NPF-38-62

ATTACHMENT A

CONTAINMENT SYSTEMS

INTERNAL PRESSURE

FIGURE 3.6-1

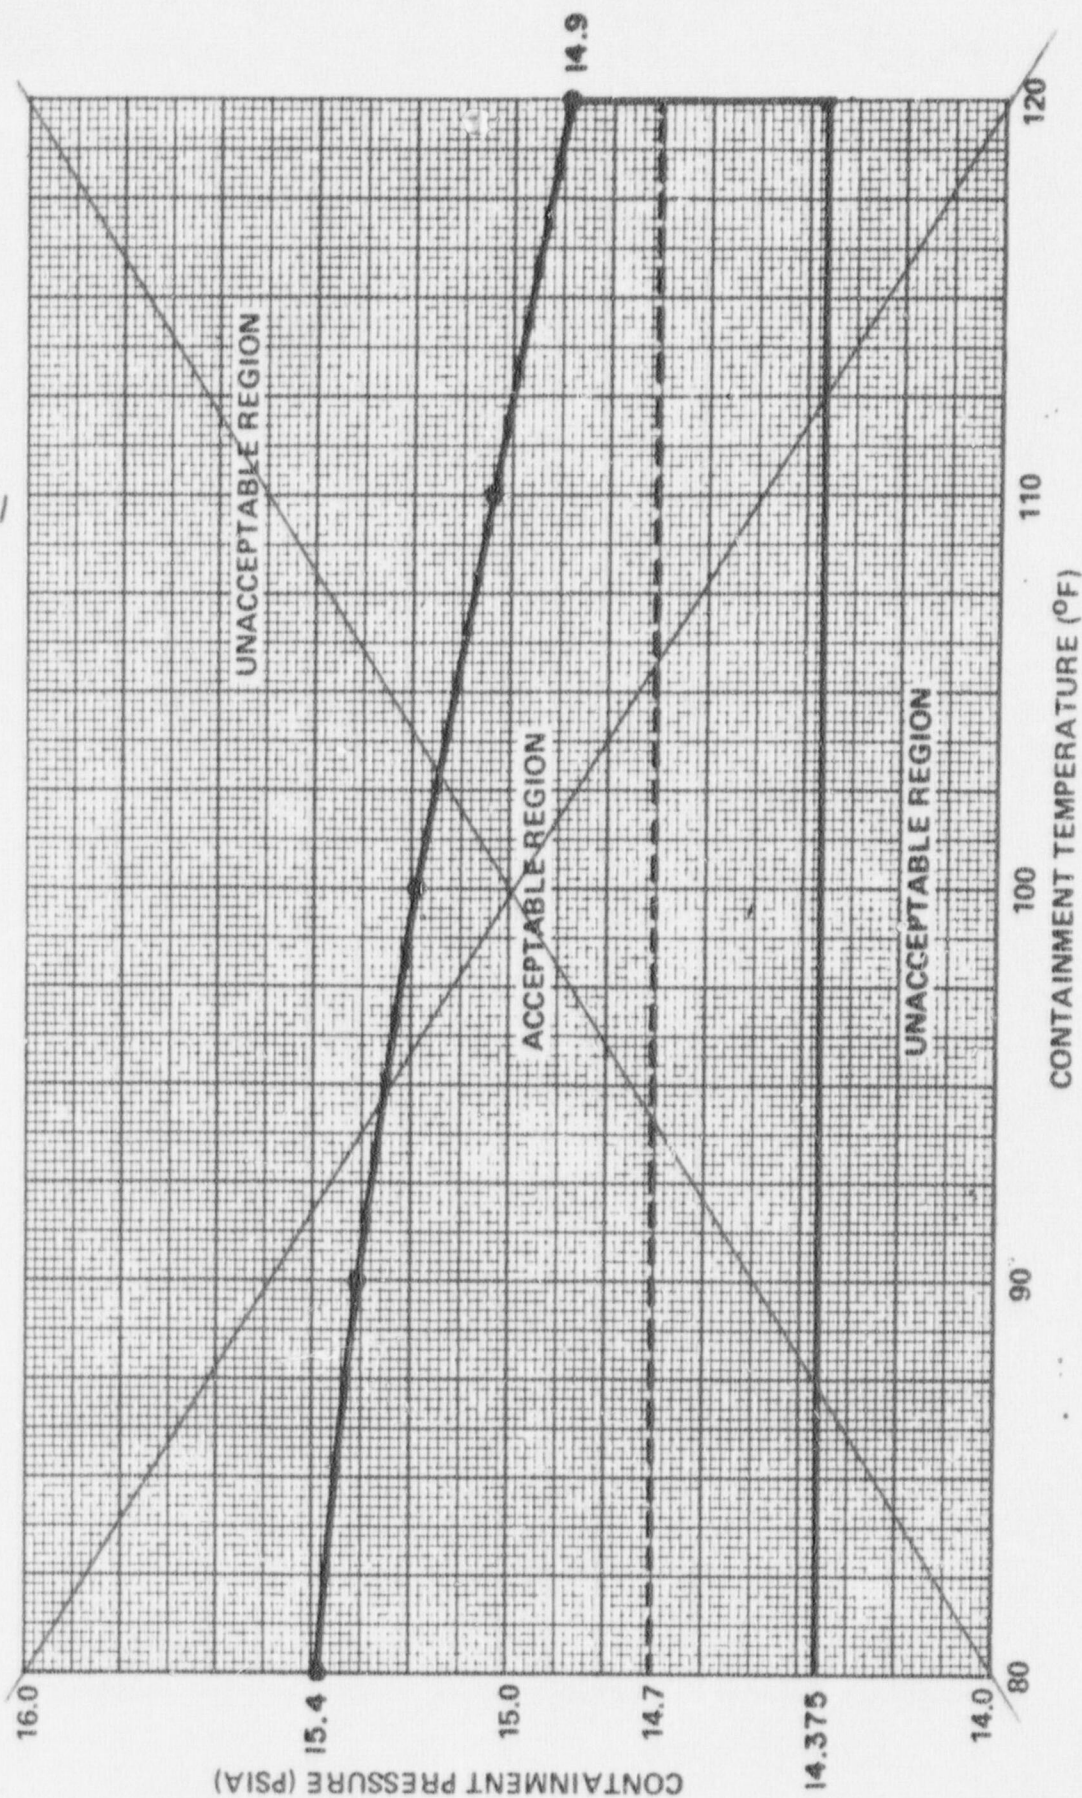
3.6.1.4 Primary containment internal pressure shall be maintained ~~within the limits of Figure 3.6-1.~~ *LESS THAN 20 INCHES H₂O GAUGE AND GREATER THAN 14.375 psia.*

DELETE
FIGURE 3.6-1

INSERT

The maximum peak pressure expected to be obtained from a LOCA event is 43.2 psig. The limit for initial positive containment pressure of +20 inches water (approximately 0.72 psig) will limit the total pressure to less than 44 psig which is less than the design pressure and is consistent with the safety analyses. The limit for initial positive containment pressure includes a correction of 1.20 inches water for possible instrument error and an additional 0.94 inches water for conservatism.
